APPLICATION NO.	FILING DATE	FIRST NAMED INVENTOR	ATTORNEY DOCKET NO.	CONFIRMATION NO.
10/517,839	12/15/2004	Young Il Park	3449-0418PUS1	9010
2292	7590	08/04/2006	EXAMINER	
BIRCH STEWART KOLASCH & BIRCH PO BOX 747 FALLS CHURCH, VA 22040-0747			NGUYEN, TRAN N	
			ART UNIT	PAPER NUMBER
			2834

**Advisory Action
Before the Filing of an Appeal Brief**

DETAILED ACTION

1 of 6

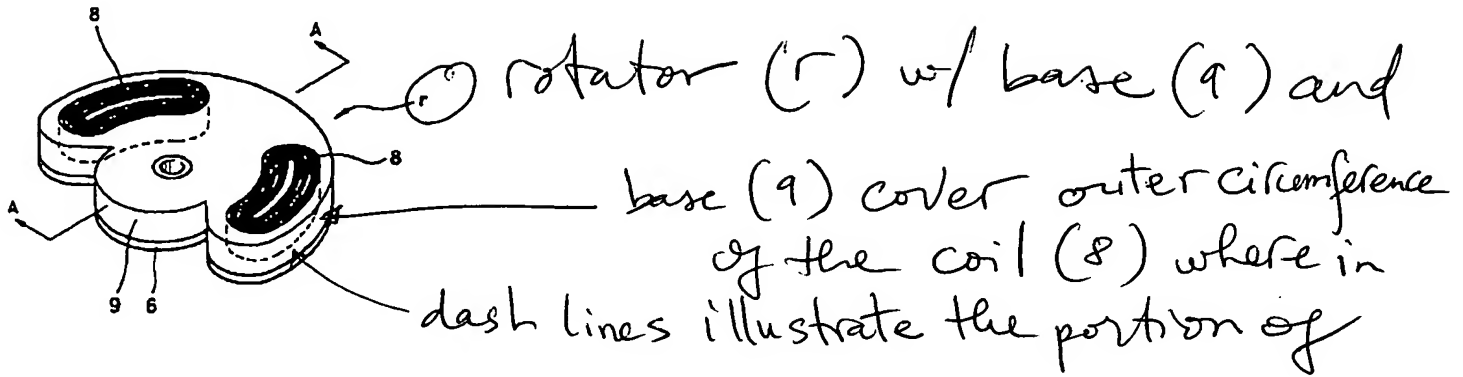
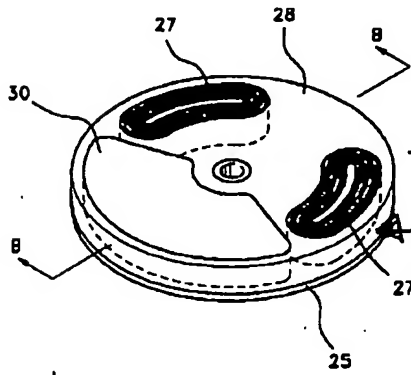
the coil being covered by
the rotator's base (9)

Thus, the rotator does

covers the outer circumference
of the coil

2 of 6

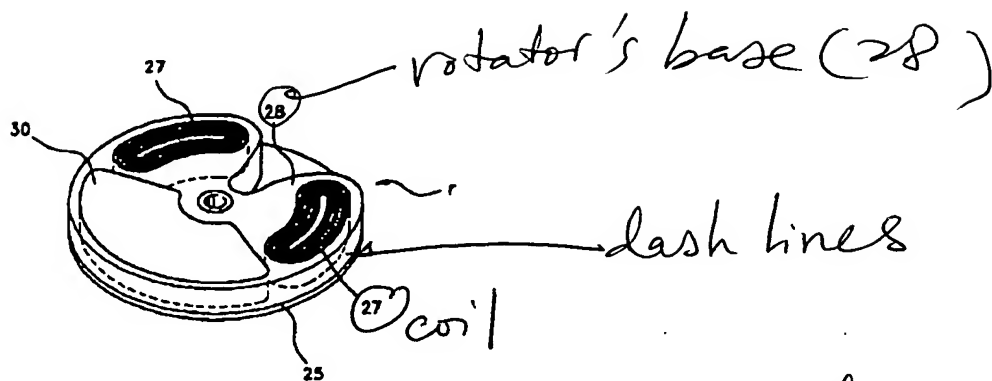
Thus, rotator does covers
the outer circumference of
the coil

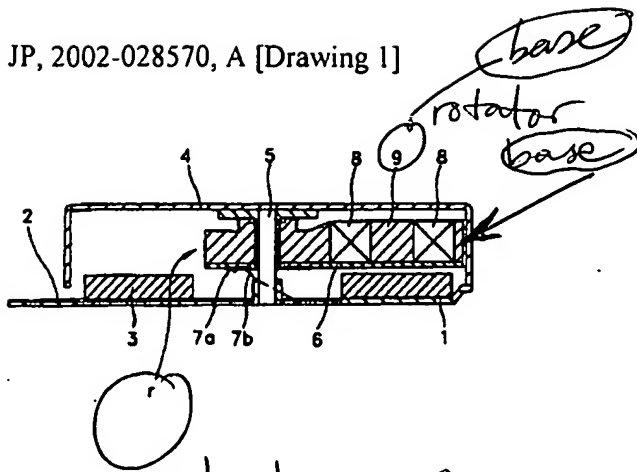
Rotator (r) with resin base (9)
 extended around coil (8);
 therefore, covers the outer
Circumference of the coil

5 of 6

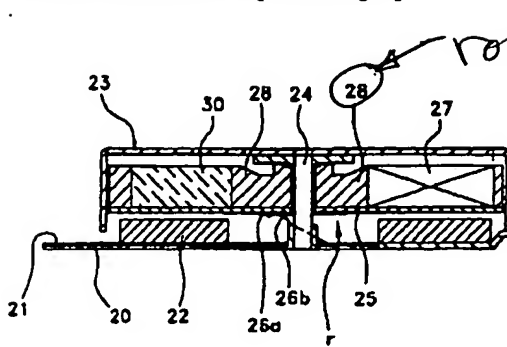
rotator's base (28) surrounds the coil (27)

again showing

rotator covers circumference outside of the coil —
